### **DEFINITE PROJECT REPORT/ ENVIRONMENTAL ASSESSMENT (SP-23)**

## **AMBROUGH SLOUGH HABITAT REHABILITATION AND ENHANCEMENT PROJECT**

Pool 10  
Upper Mississippi River  
Crawford County, Wisconsin

December 2000

DRAWING NUMBER  
**PLATE 7**  
SHEET 5 OF 05

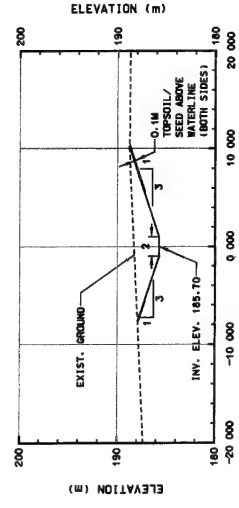
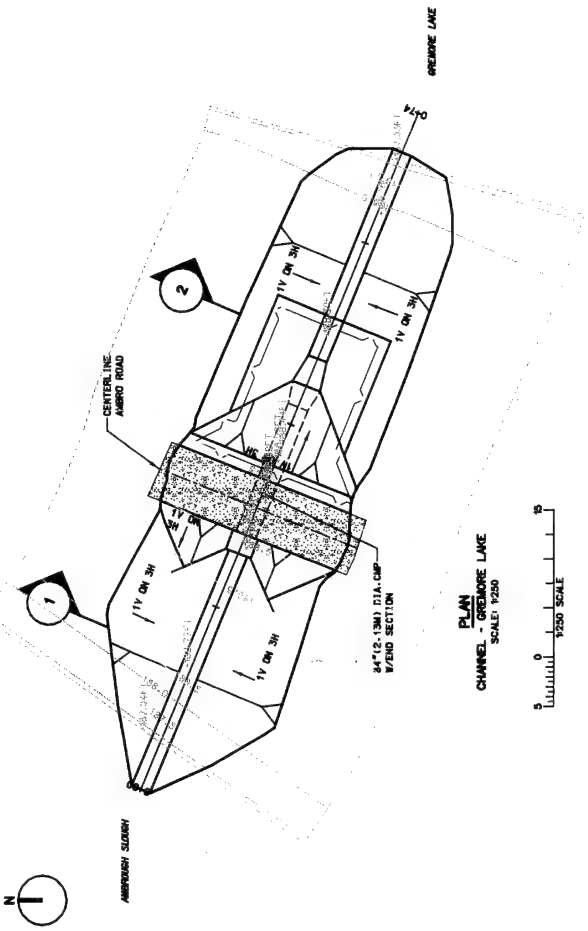
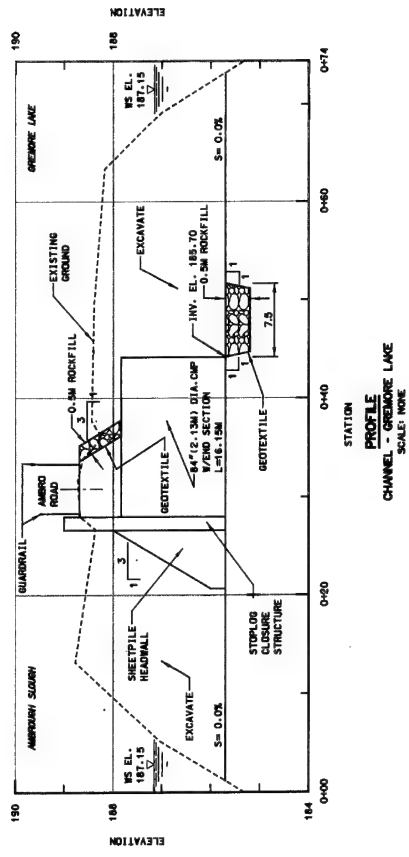
21 Page 7-31 to 32; 7.2.5.3: Typo. The range of flow should be 0.08 to .11 cms. The bottom elevation of the dredge channel to Gremore (185.32m) does not match Plate 7 (185.70m). More verification of the water surface elevation during winter conditions is needed to verify the assumed slope for culvert flow calculations. Please add more narrative after the "channel was initially designed with a 1.2m culvert" (i.e. what is the final or proposed design).
